CALIFORNIA COASTAL COMMISSION

W13b

A-5-LGB-20-0015 (Contursi)

July 8, 2020

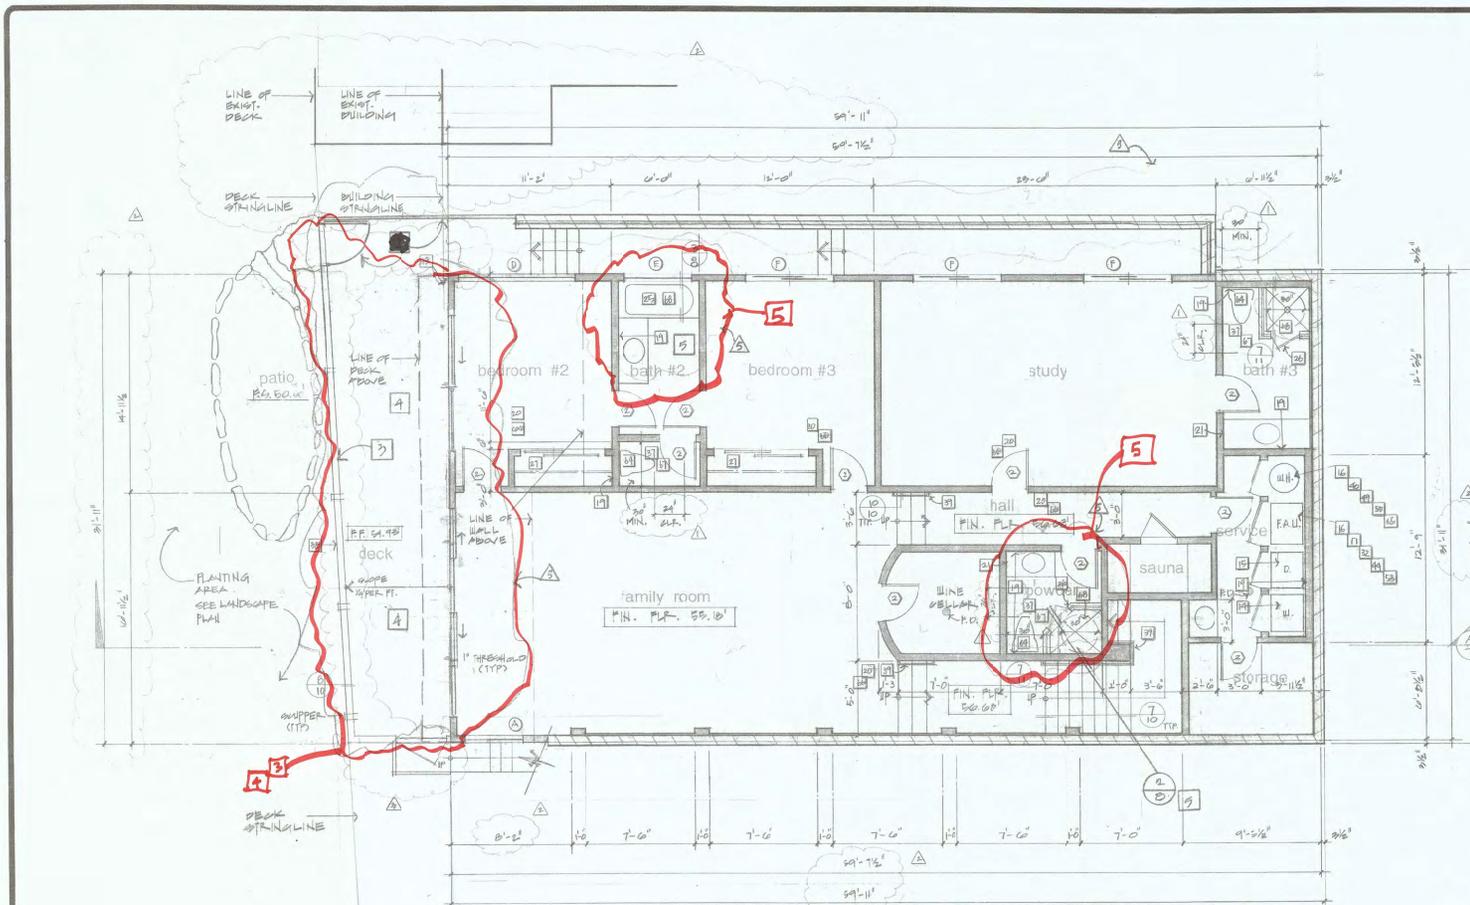
To defer the removal of a violation (the stairs) and move forward with permitting was based on the statements of the applicant's attorney who stated that it 'wasn't fair' and that the owners should have a hearing to decide the matter. However, the recommendation to remove the staircase and restore the slope was in the staff report and the owner should have asked for a continuance prior to the hearing to make a case for retention of the violation. What wasn't 'fair' was the applicant's failure to prepare for the hearing and to expect another opportunity to argue for retention while being allowed to move forward with the requested development.

We would ask that the removal of the unpermitted staircase (as well as the removal of any other unpermitted development) and the restoration of the slope via a habitat restoration plan be required by the Commission during a de novo review of the application.
